UNITED STATES PATENT AND TRADEMARK OFFICE

APPLICATION NO.	FILING DATE	FIRST NAMED INVENTOR	ATTORNEY DOCKET NO.	CONFIRMATION NO.
10/729,231	12/05/2003	Roger Thomas	P-US-PR 1107	9218

Office Action Summary	Application No.	Applicant(s)	
	10/729,231	THOMAS, ROGER	
	Examiner	Art Unit	
	Shelley Self	3725

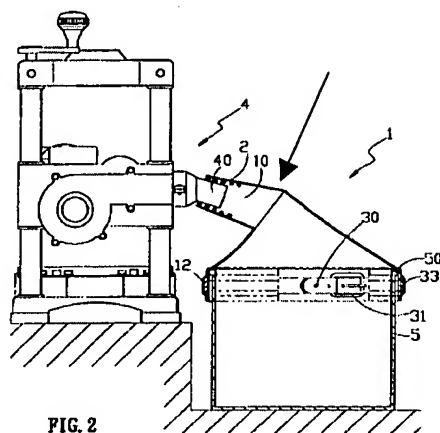
With regard to claim 15 and 16, as best as can be understood, Wang discloses a part spherical shaped section (10; fig. 2) that curves the path of the debris as it passes through the part spherical section.

As to the 90 degrees (clm. 16) Examiner notes that the spherical section (10) curves the path of the debris and that some of the debris will follow the spherical section (10) to a highest most point and fall by air and gravity force downward, i.e., at a 90 degrees (fig. 2).

Wang (6,712,106) disclose, Air and gravitational force from the top of the dome section curve the debris substantially, 90°
